Addendum No. 1

RE: Contract # C203964
WBS # 2017CPT.01.11.10581 Etc.
STATE FUNDED
Martin County
1 Section of US-13 and 1 Section Of US-17

January 17, 2017 Letting

The following revision has been made to the plans (Sketch Maps):

TYPICAL SECTION NO. 1

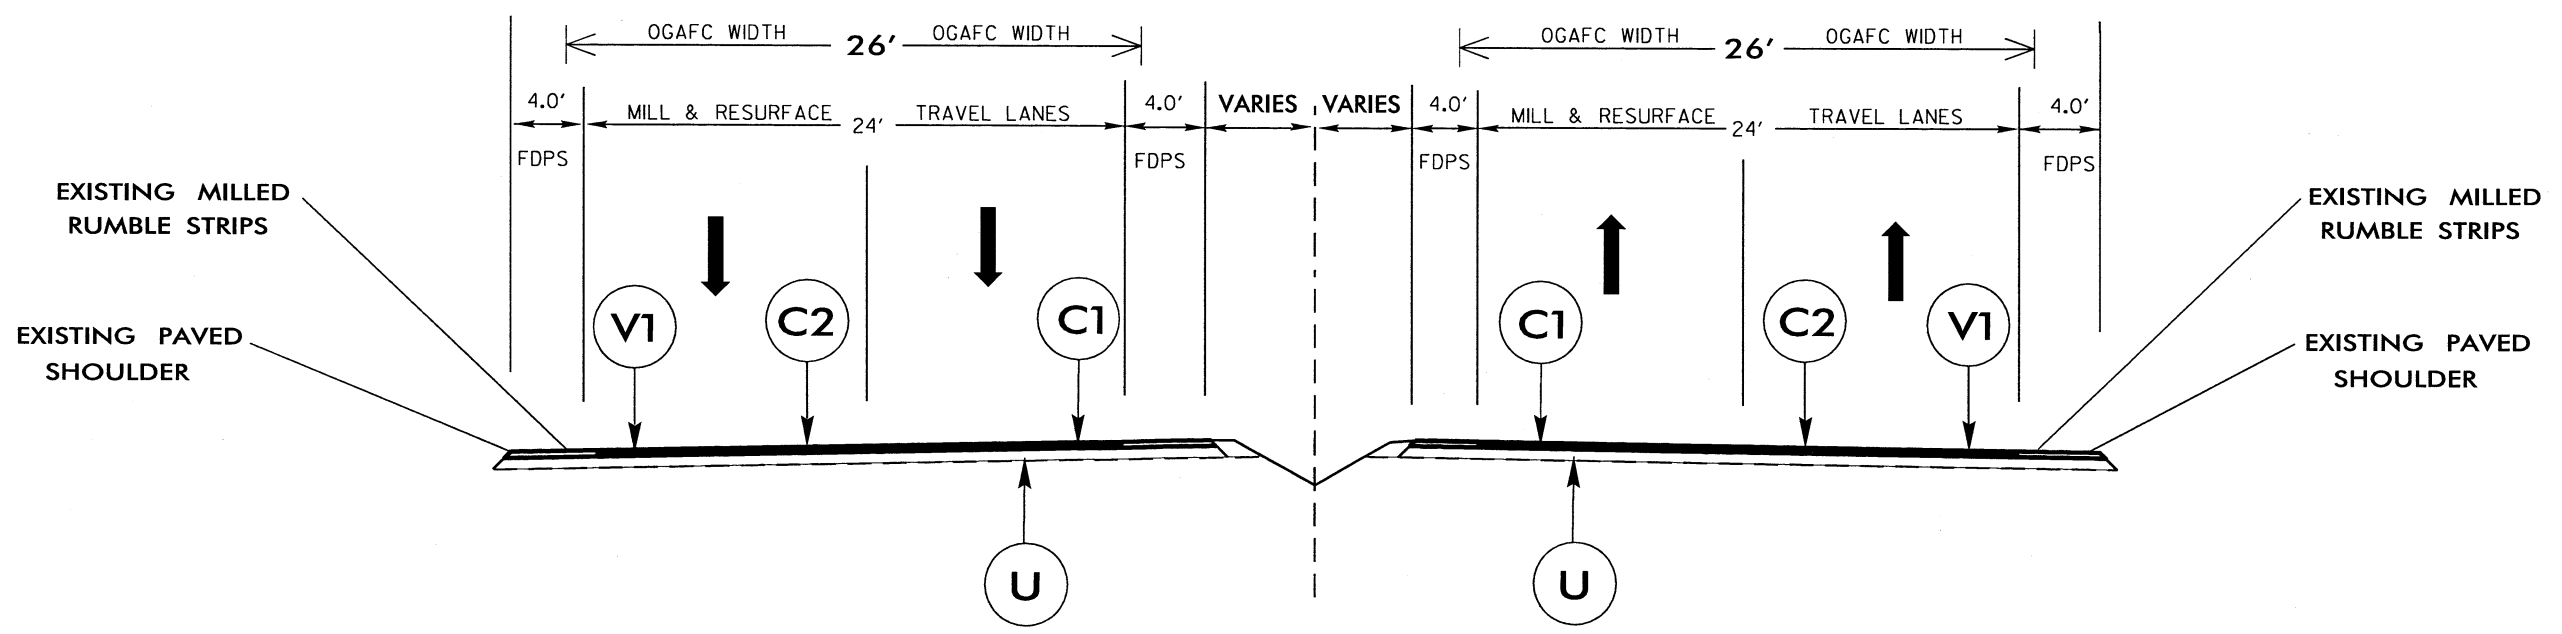
Sheet No.	Revisions
3	Revised Typical Section No. 1 right shoulder. Modified notes
5	Revised to remove the asterisks and note associated with the asterisk. Added column for Mobilization

2nd Revision: 01/06/17 SPF
